TIGER 60

Instruction manual addendum for GPMA0968

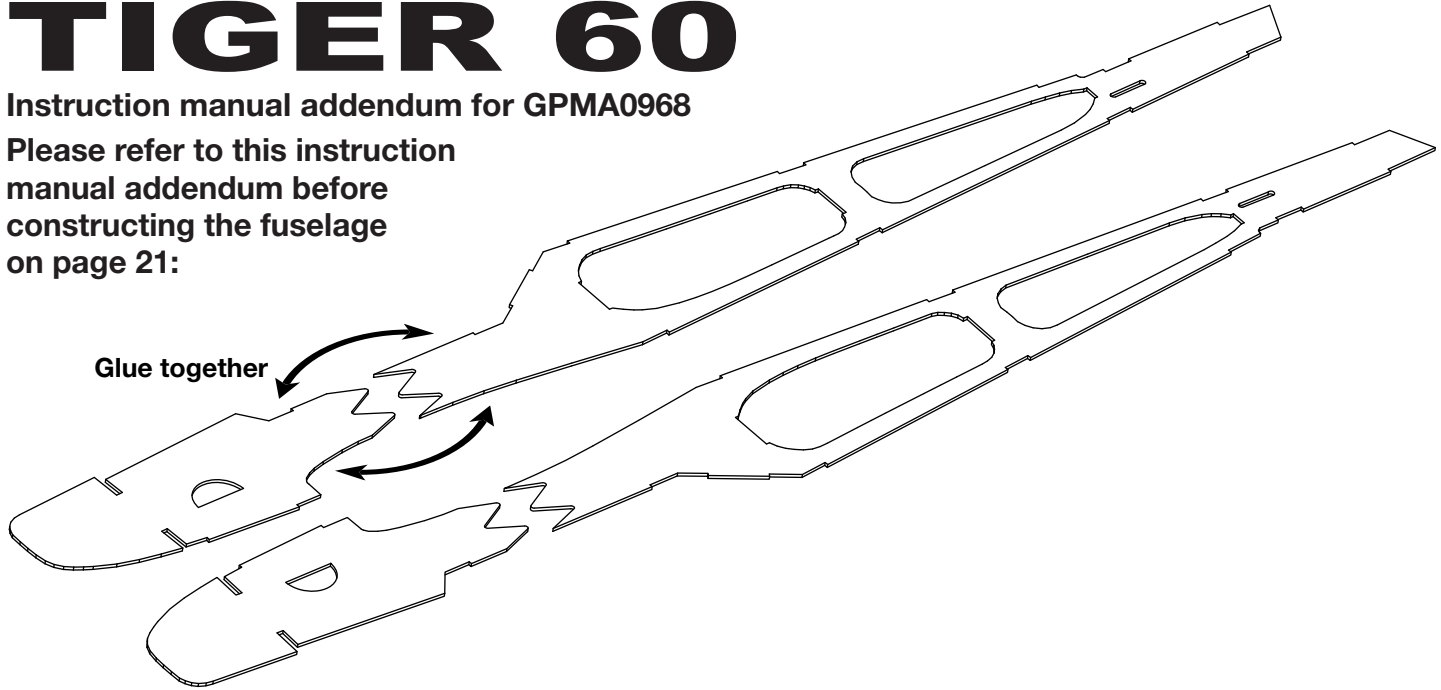
Please refer to this instruction manual addendum before constructing the fuselage on page 21:

The fuselage sides are now supplied in two pieces which must be glued together before adding the doublers. Working over waxed paper or other thin, protective film, test-fit, then glue together the two pieces of each side with whatever glue is your preference. After the glue has hardened lightly sand the sides to remove excess glue or high spots, then proceed with construction.
